## OTTAWA LIGHT RAIL TRANSIT

### Track Assurance Report 1 – Tunney's Pasture to Tunnel Portal West

<b>Document Ref:</b> OLR-22-0-0000-REP-0001		<b>Document Title:</b> Track Assurance Report 1 – Tunney's Pasture to Tunnel portal west	
<b>Revision 0</b>	<b>Date: 22/10/2018</b>	<b>Owner: B.Venables</b>

Photo no. 3 (top): westbound low rail looking towards the tunnel mouth at 100km 408m

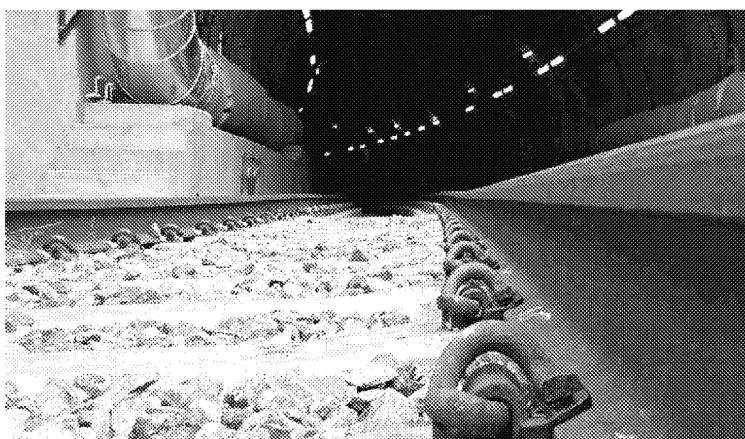
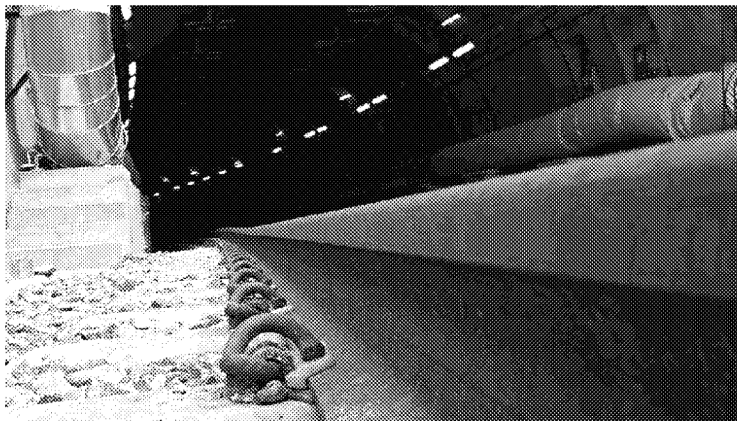
The alignment across ballast to slab and slab to ballast transitions are robust, except for the westbound exit from the main tunnel. This exhibits loss of design on both rails of approximately 5mm, as seen in photos 3 and 4 below:

Photo no. 4 (bottom): westbound high rail looking towards the tunnel mouth at 100km 408m

The assessor recommends that remedial action is taken to reinstate the design prior to the opening to passenger operations. All other ballast/slab transitions are robust, and do not present any ride quality concerns.

Photo 15 (left): Restraining rails in Pimisi west bound platform. Photo 16 (right): Restraining rails in Pimisi east bound platform.

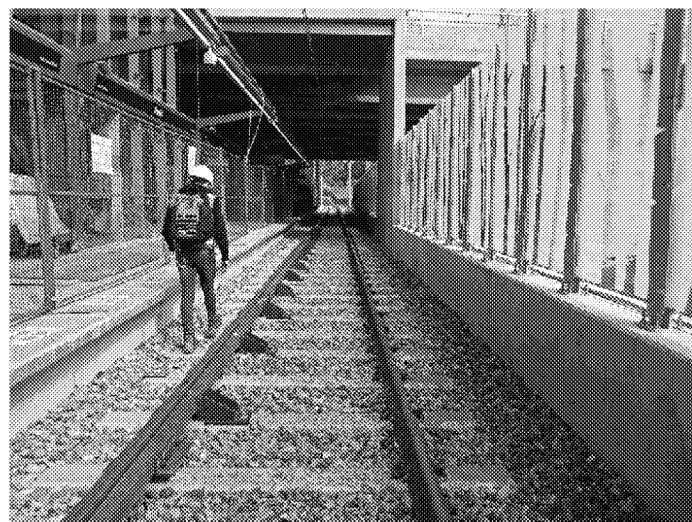
However, as part of good derailment risk management, restraining rails have been provided in Pimisi station on both lines.

Photo no. 17 (left): start of Jordan rail protection west bound into Bay View station.

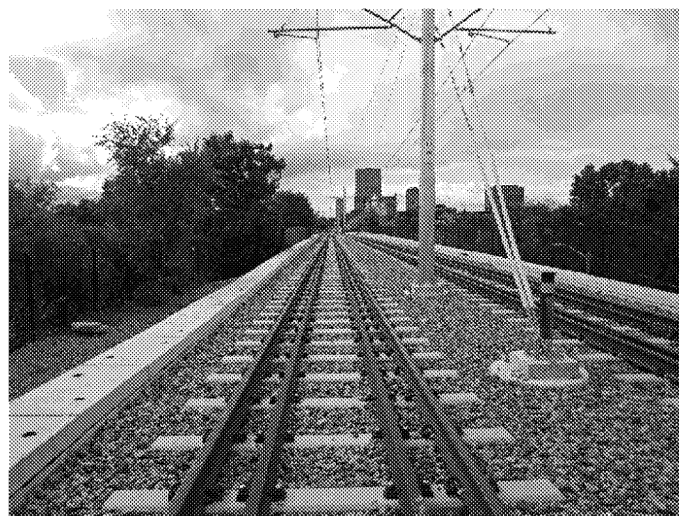
Additionally, there is a long section of “Jordan Rail” (guard rails) track between Bay View and Tunney's Pasture.

Photo no. 18 (right): view of Jordan rails on both lines, taken 99km 350m looking towards Tunney's pasture.

Photo no.20: Installed buffer stop at Tunney's Pasture, with compliant friction resistance devices.

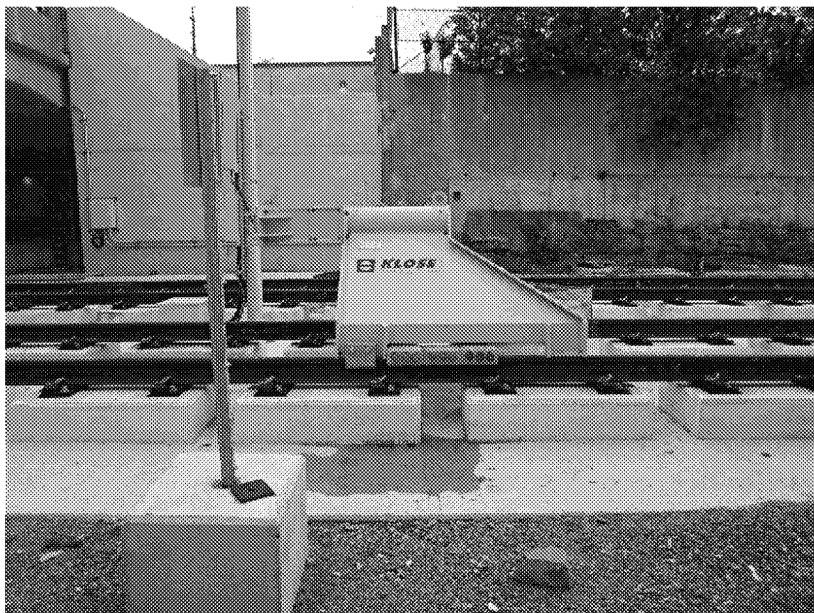
The assessor has been provided with the design remit [Ref.01] and manufacturer's drawings [Ref.17 and Ref.18]. These were sufficient to demonstrate that the risk of tram running off the end of the track has been mitigated, and that the requirements of the PA are validated.

Photos no. 21 (top) and 22 (bottom) are taken of 304pts and 303pts respectively.

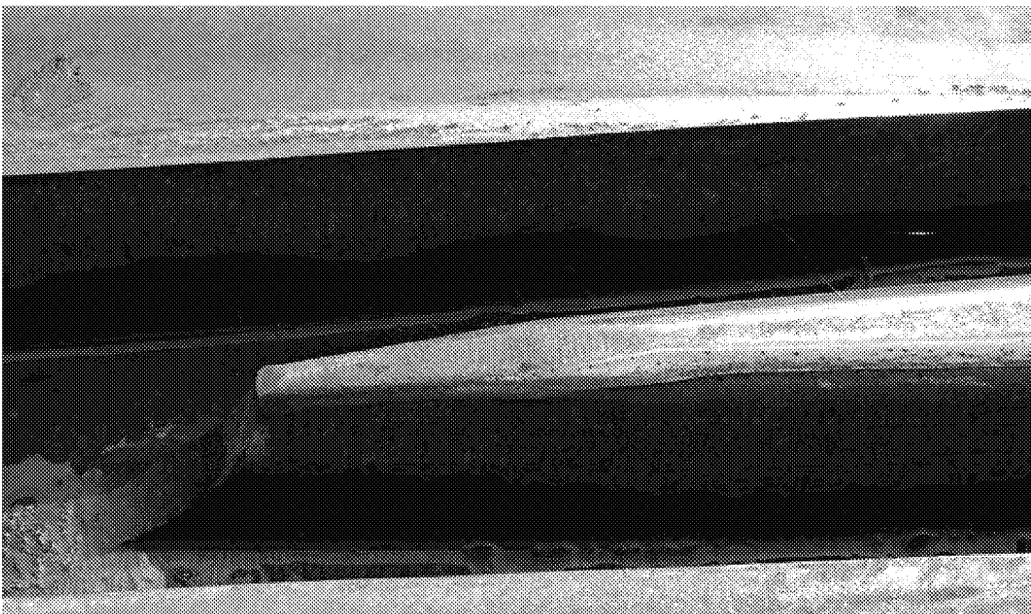
The rails are fastened by a Vossloh type fastener rather than a Pandrol fastener, as used on the plain line track. The assessor accepts that differing fastener systems are required, and that the system used is appropriate for the safe operation of the special trackwork. The assessor did observe that some fasteners were either loose or missing and need to be installed and tighten to the correct torque value within 3 months of passenger operation.

Switch blades have started to demonstrate initial lipping at approx. 3.5m to 4.5m from the switch toe. This is normal behaviour, but the lipping must be ground off before significant defects and cracks start to form within the metal. As the grinding and profiling of switches is a specialist skill, the assessor recommends that all remedial works are undertaken by the OLRT track Maintainer within the first 3 month of passenger operation (on a risk-based priority approach).

The crossing units (frogs) have started to demonstrate initial lipping and deformation under Hi-Rail vehicle and tram movements. This is normal behaviour, but the lipping must be ground off and any deformation rebuilt before significant defects and cracks start to form within the metal. As the grinding and profiling of switches is a specialist skill, the assessor recommends that all remedial works are undertaken by the OLRT track Maintainer within the first 2 month of passenger operation (on a risk-based priority approach).
